Luensmann Offsite Water Main Ext PH1
Solicitation Number: CO-00717
Job No.: 23-1043

ADDENDUM 1
11/16/2023

PLAT NO. _____
JOB NO. 12473-09
DATE MARCH 2023
DESIGNER CD
CHECKED MP DRAWN CD
SHEET C3.11

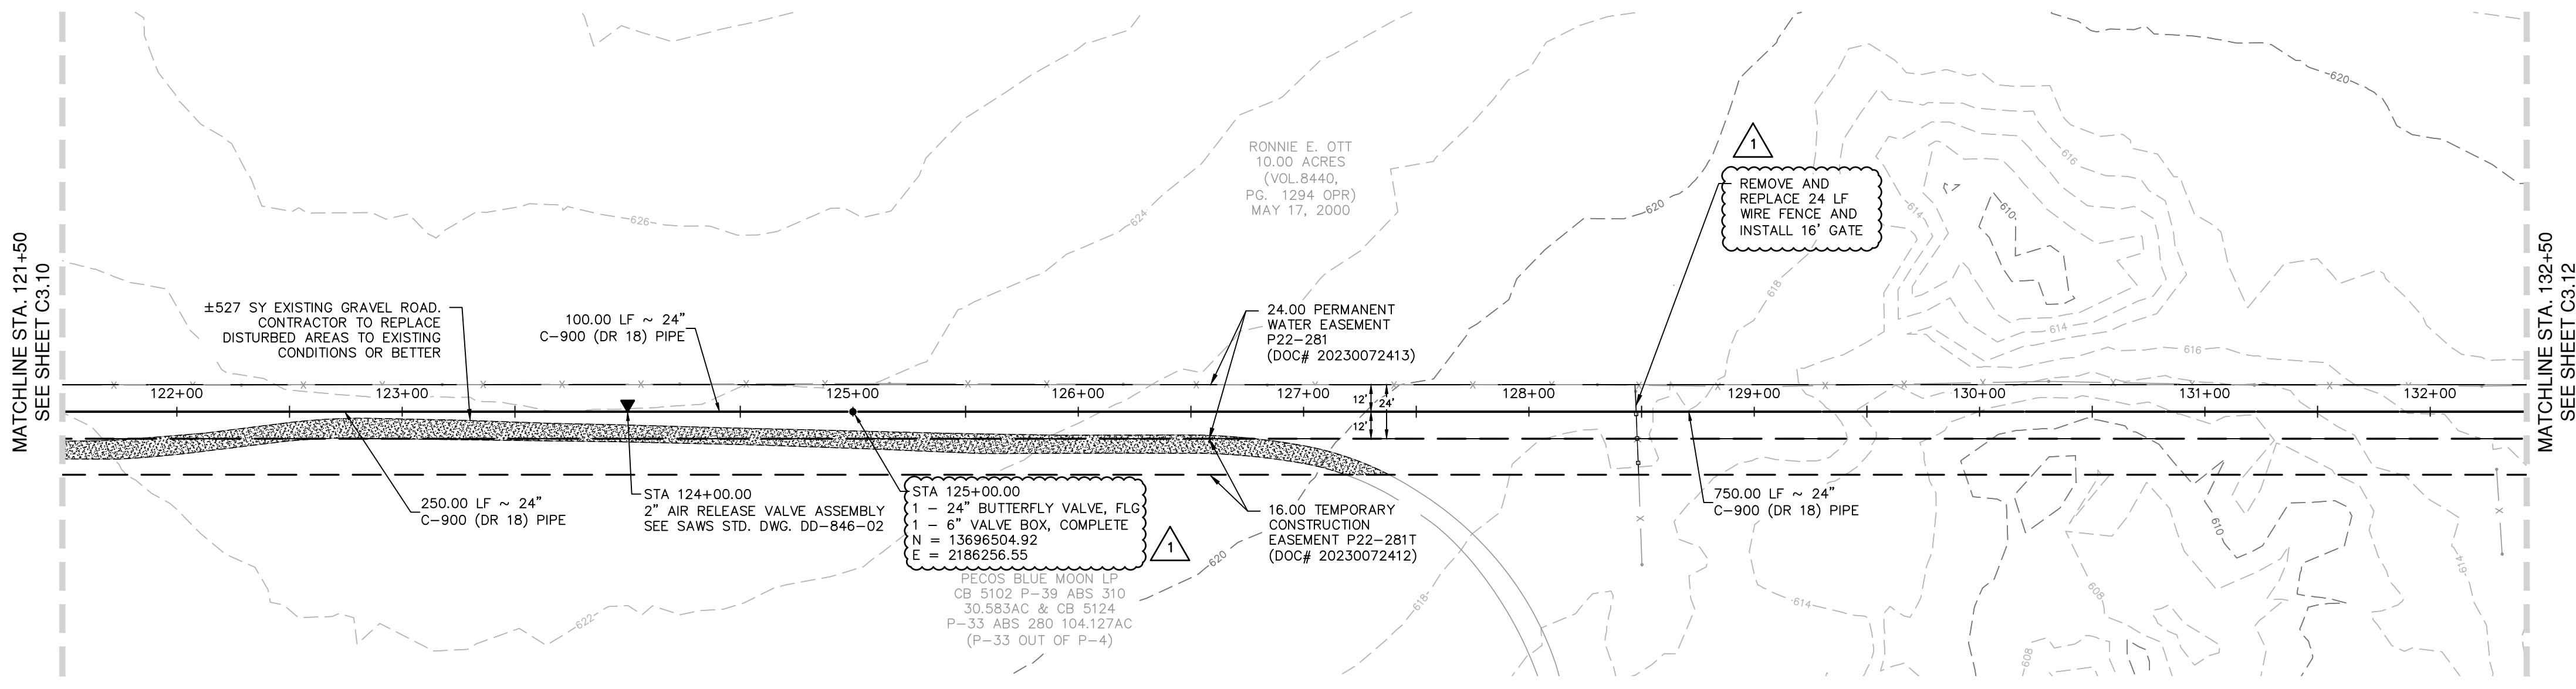
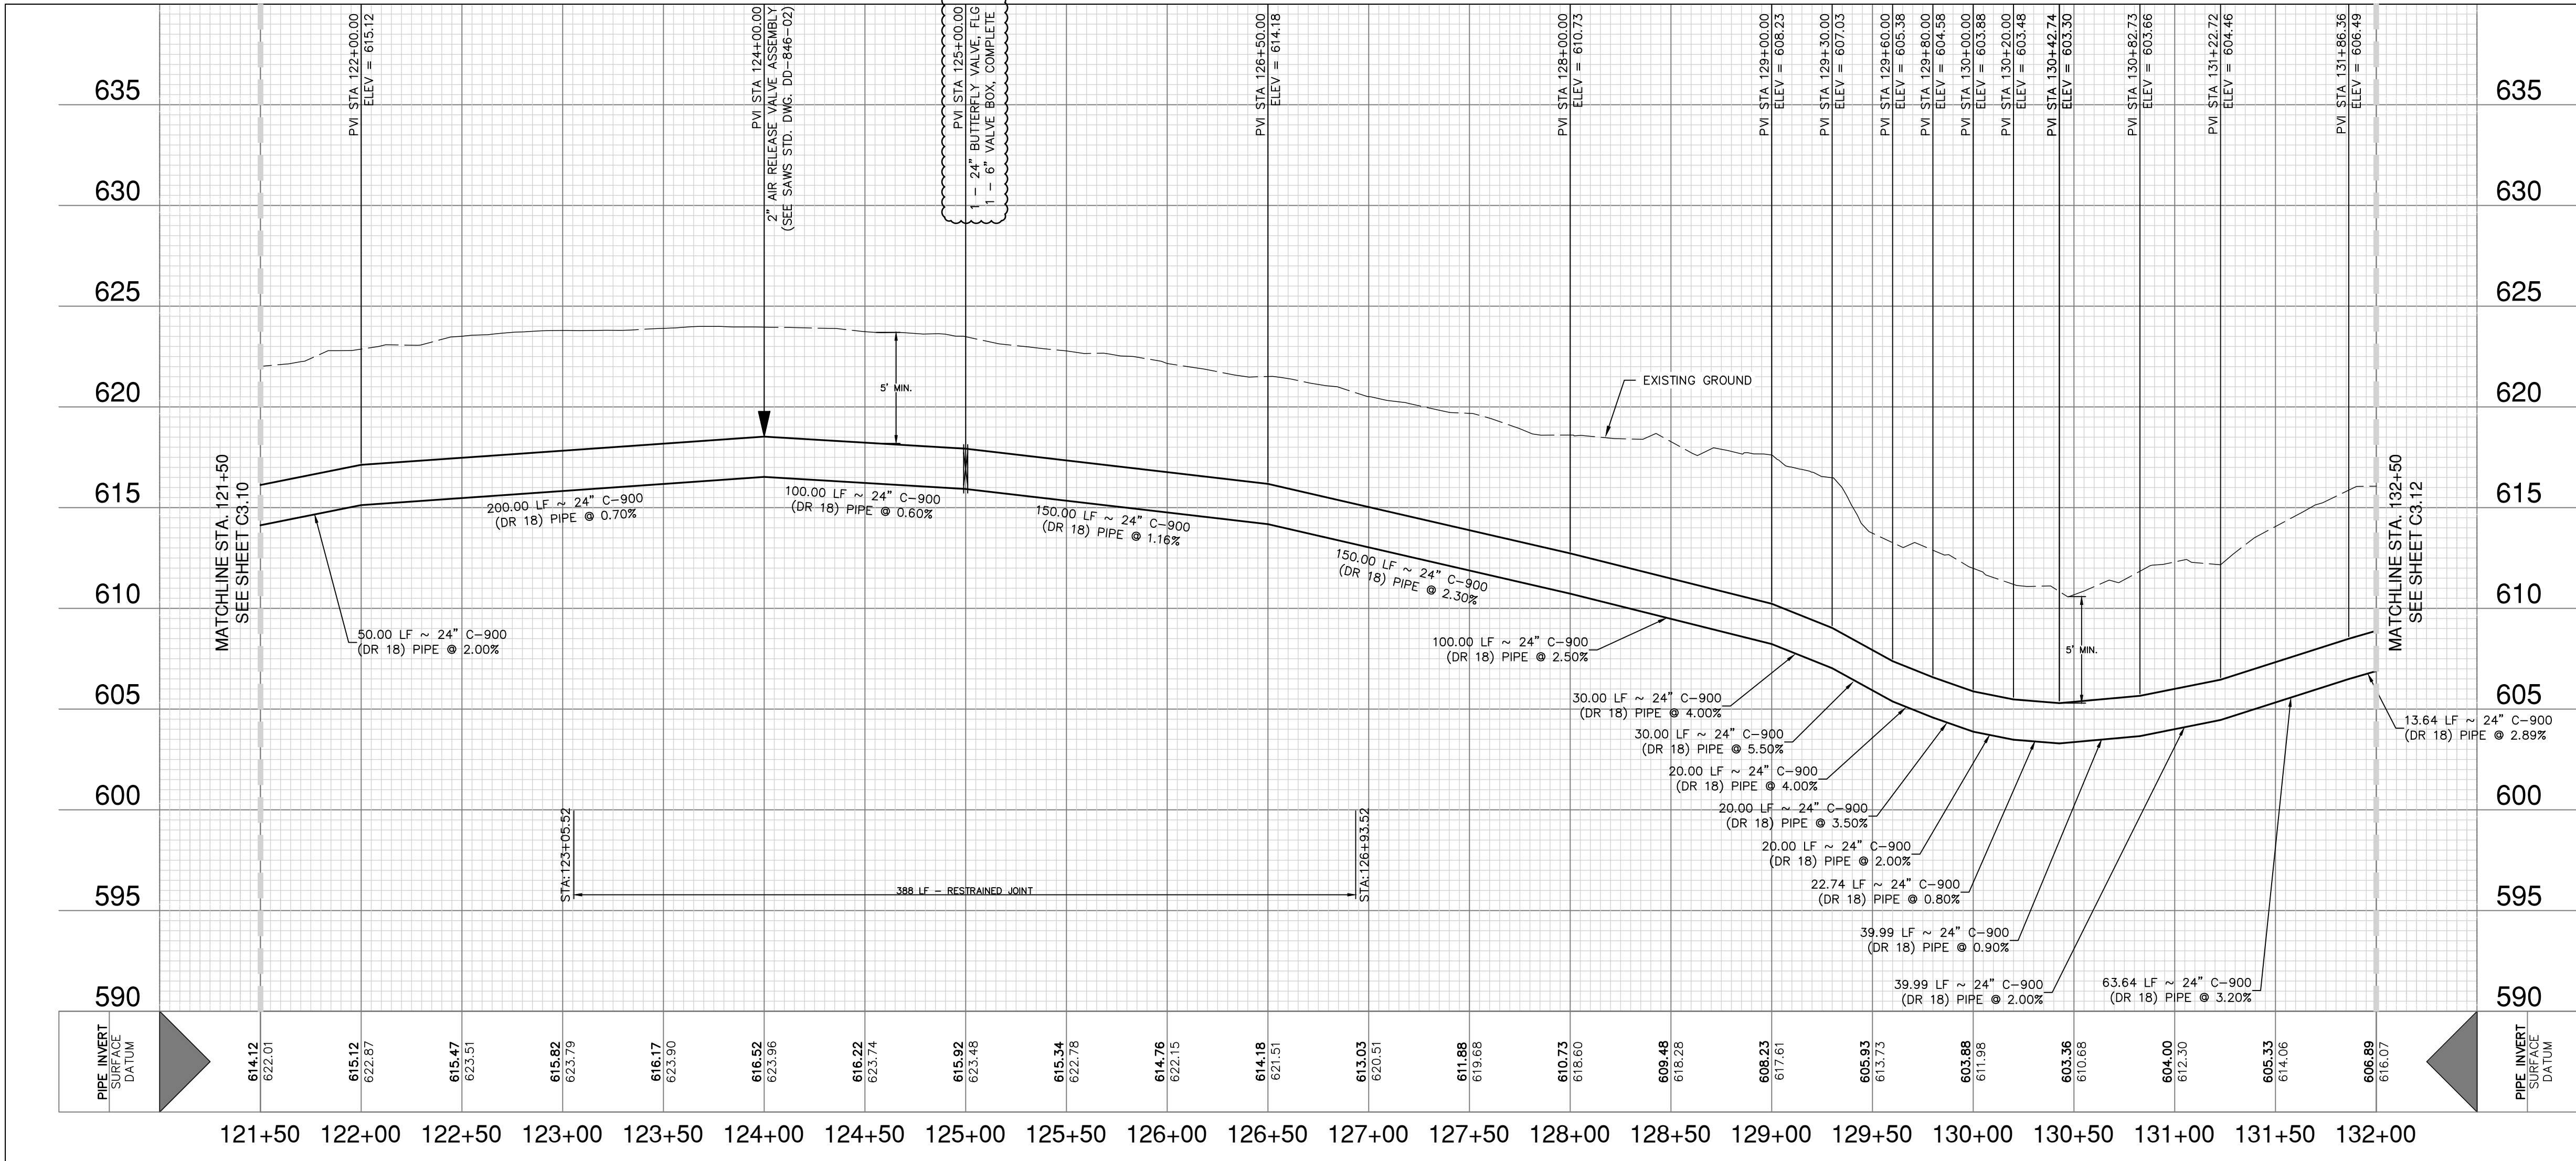
- Updated quantity table to add a Fence Gate Type 1 and Remove and Replace Existing Fence
 - Revised 24" Butterfly valve to be Flanged.
 14. Sheet C3.11: Water Main Plan and Profile Sta 121+50 to 132+50 – Remove in its entirety and replace with the attached document.

LUENSMANN OFF-SITE WATER MAIN EXTENSION (PHASE 1)
BEXAR COUNTY, TEXAS
WATER MAIN PLAN AND PROFILE STA 132+50 TO 141+50
PLAT NO. _____
JOB NO. 12473-09
DATE MARCH 2023
DESIGNER CD
CHECKED MP DRAWN CD
SHEET C3.12

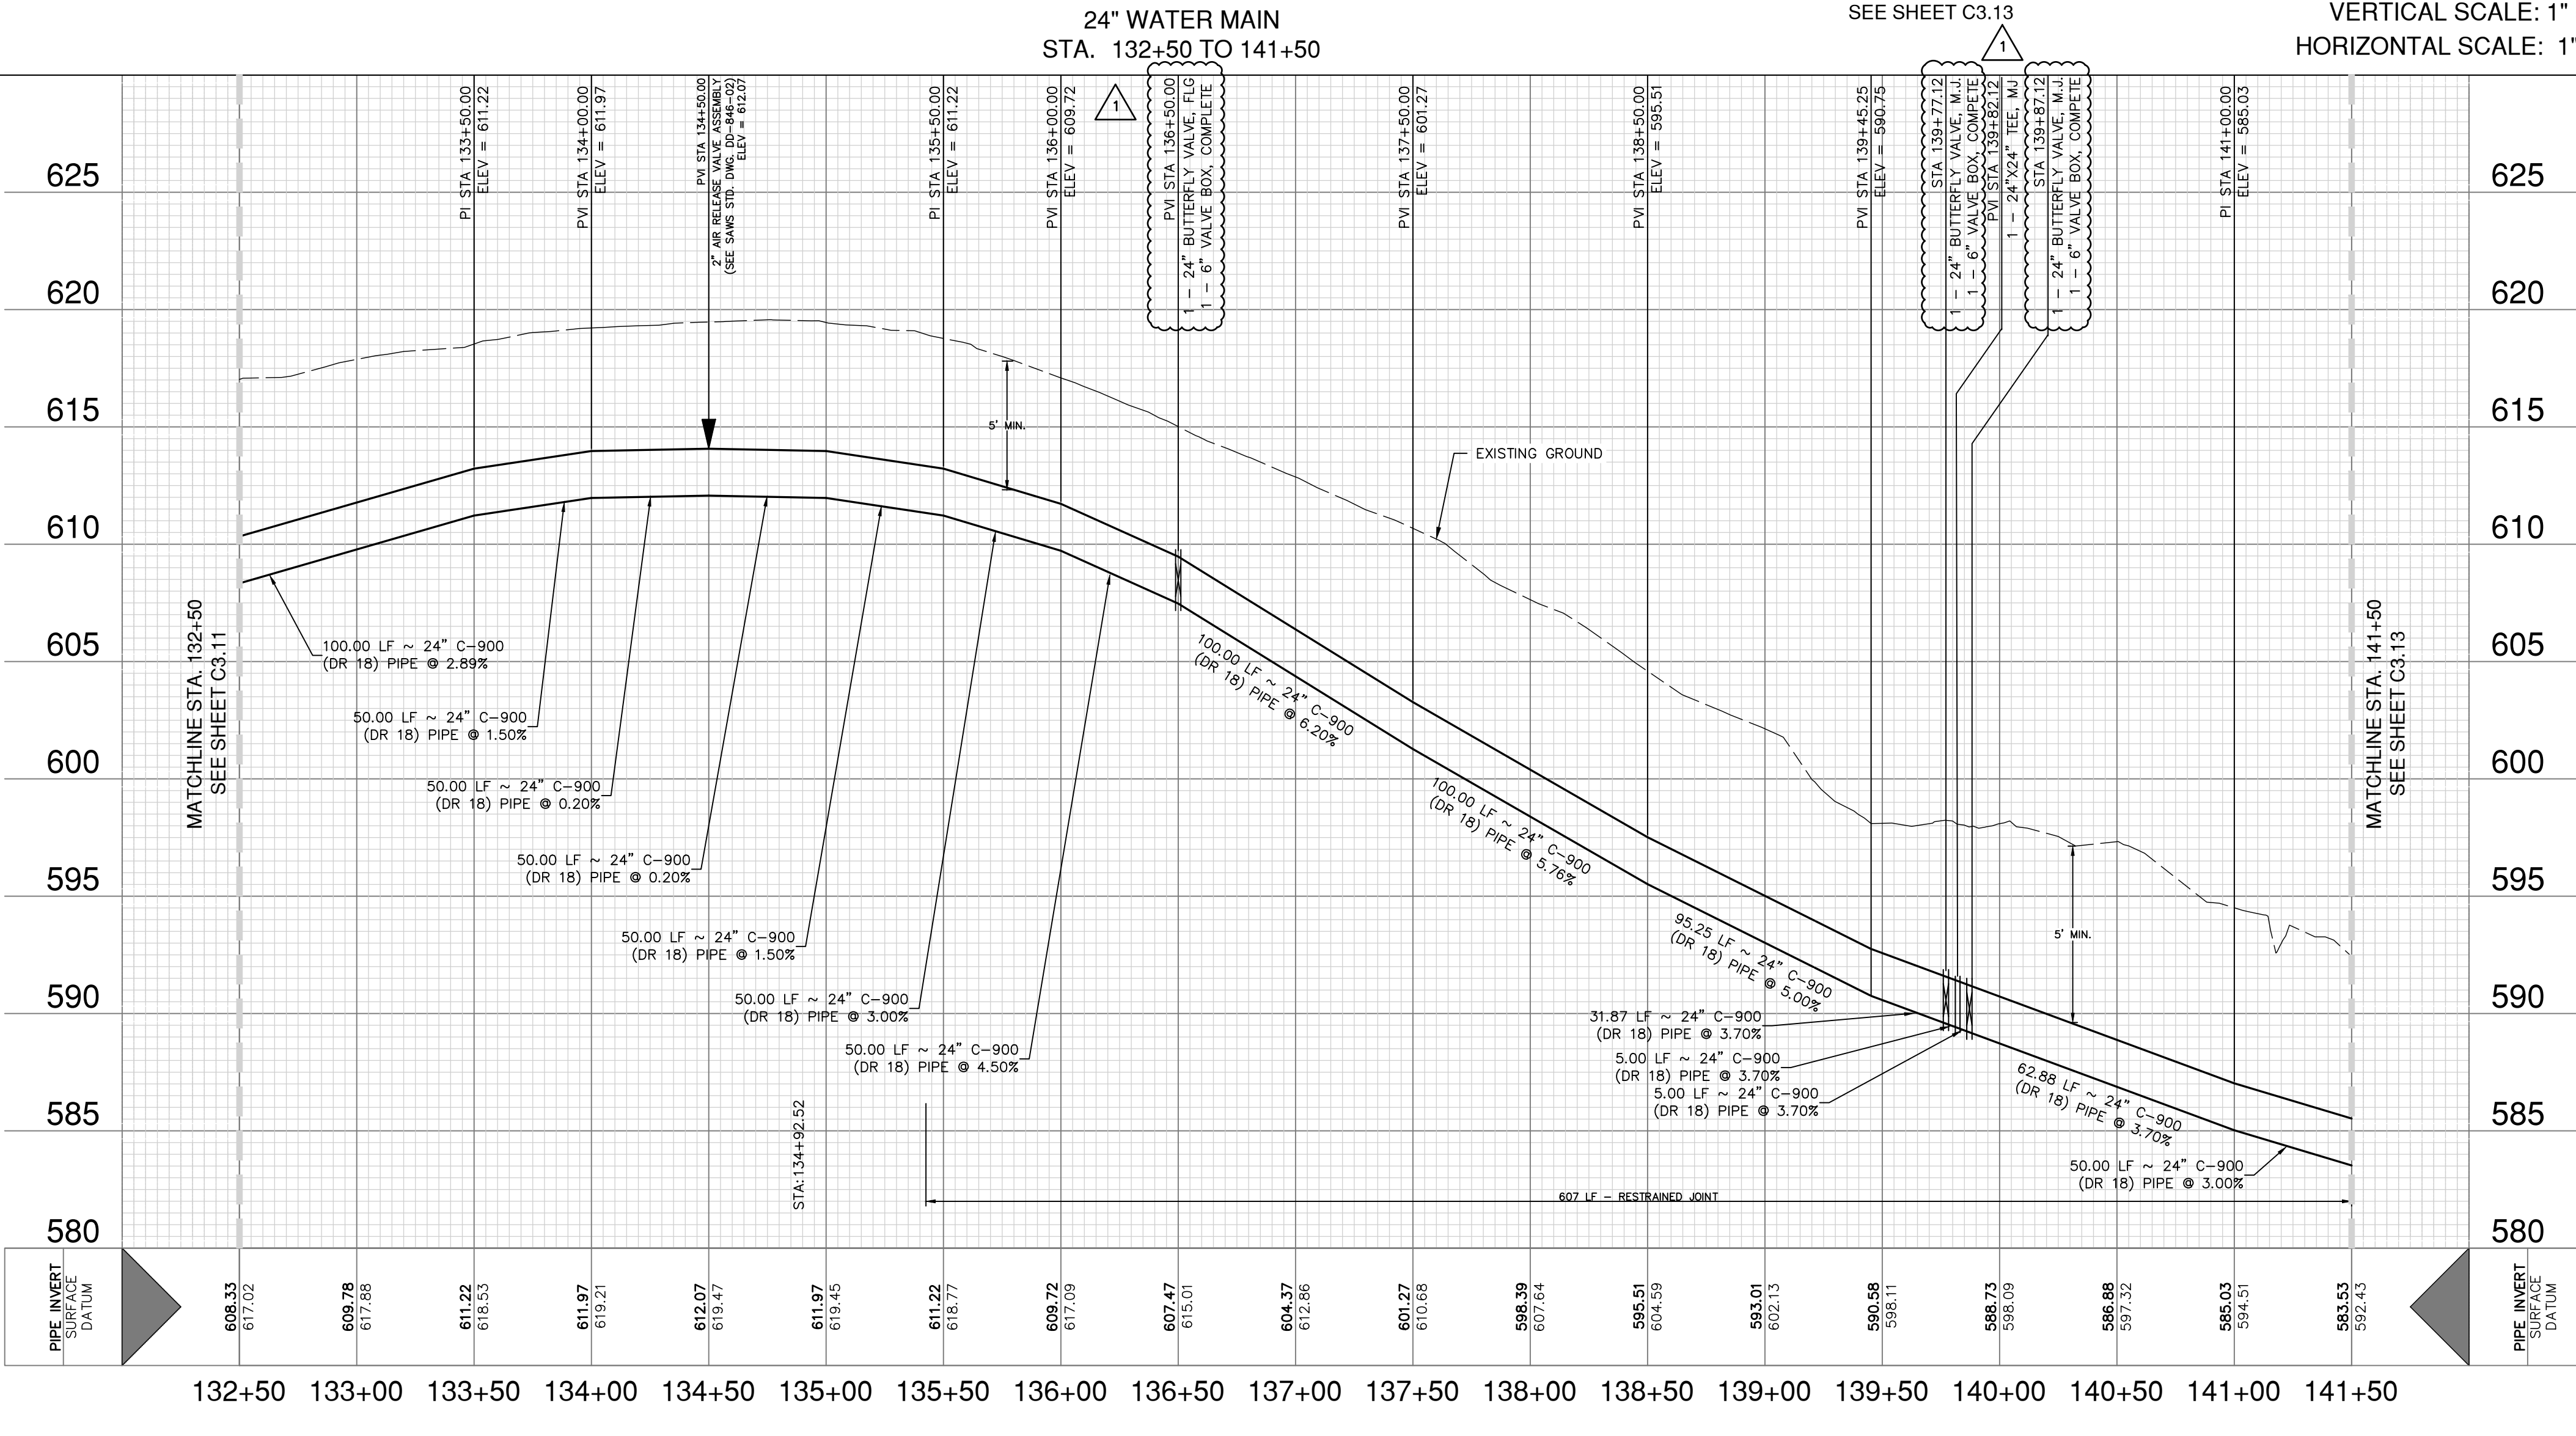
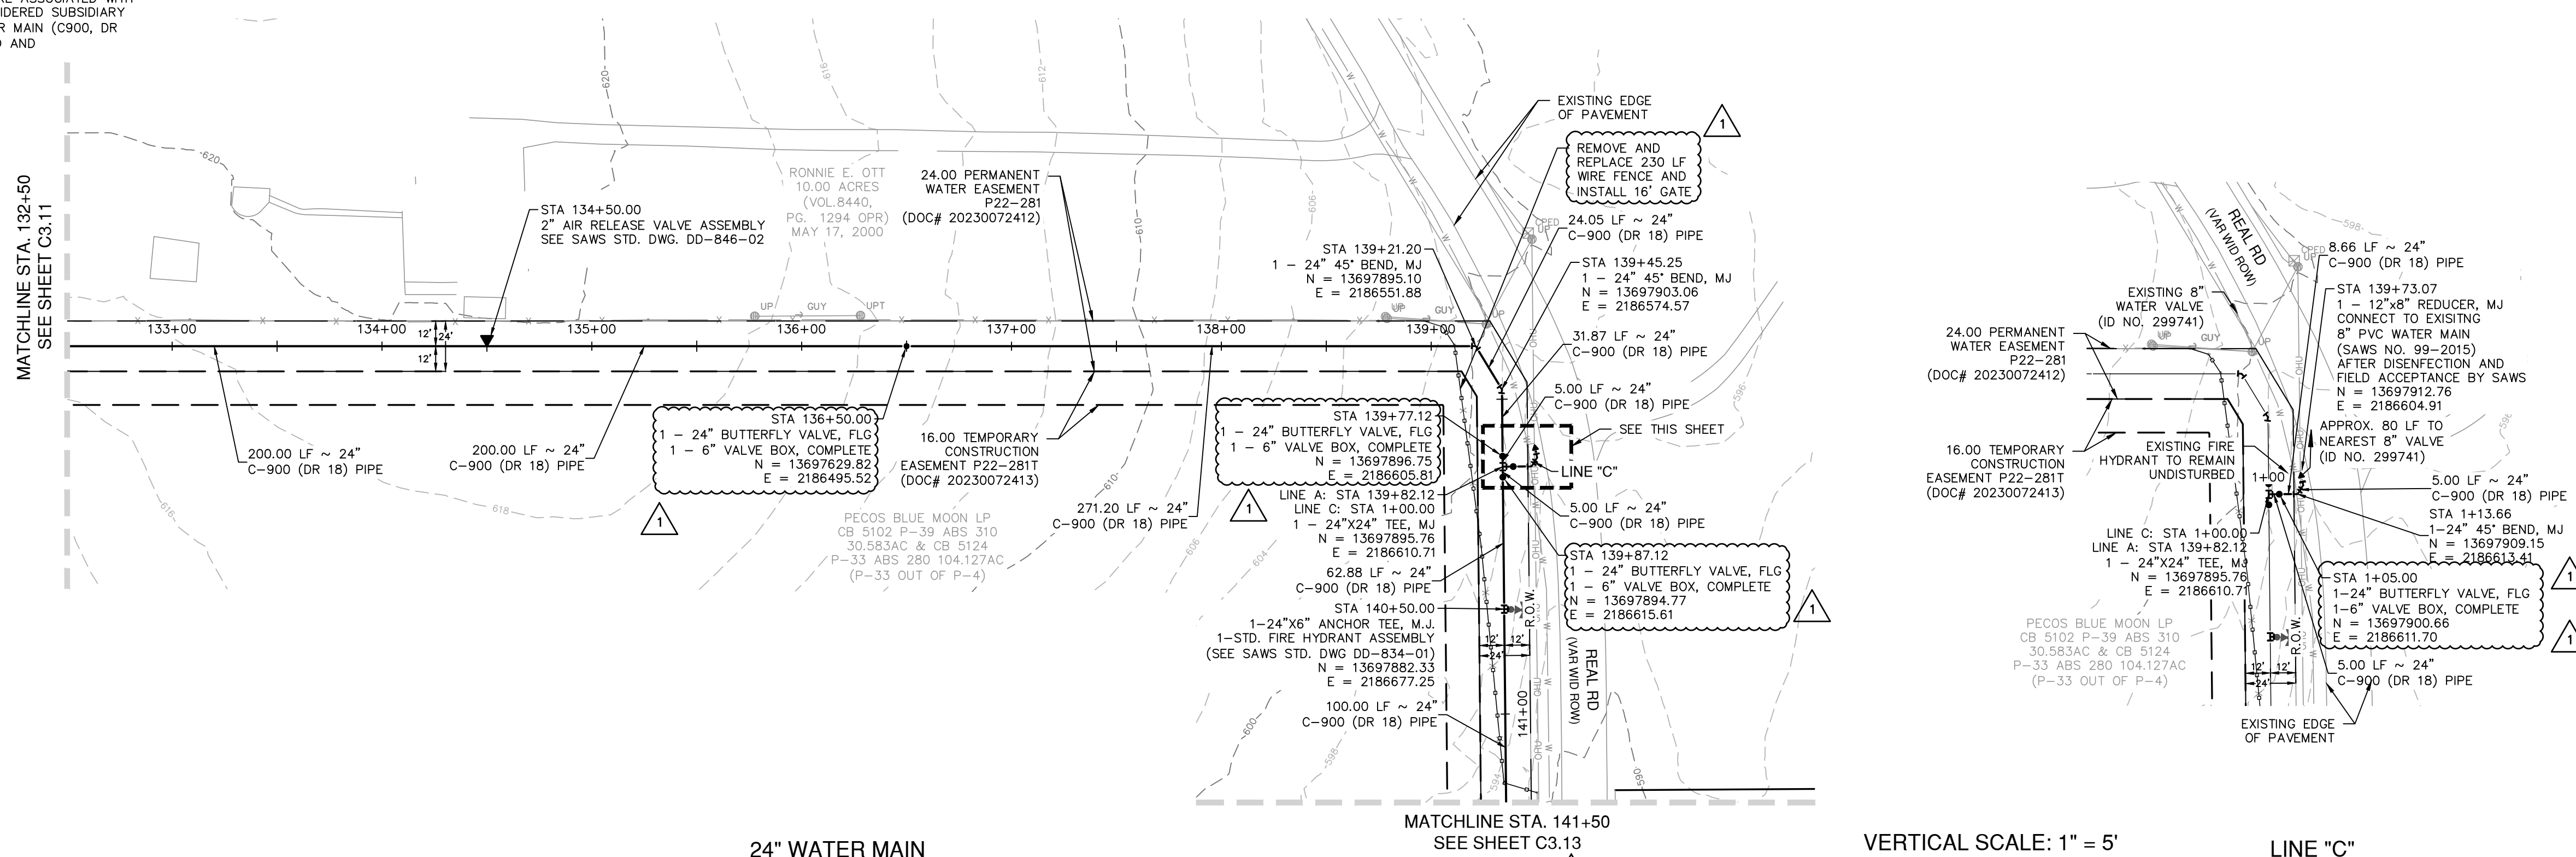
- Updated quantity table to add a Fence Gate Type 1 and Remove and Replace Existing Fence
 - Revised 24" Butterfly valve to be Flanged.
 15. Sheet C3.12: Water Main Plan and Profile Sta 132+50 to 141+50 – Remove in its entirety and replace with the attached document.
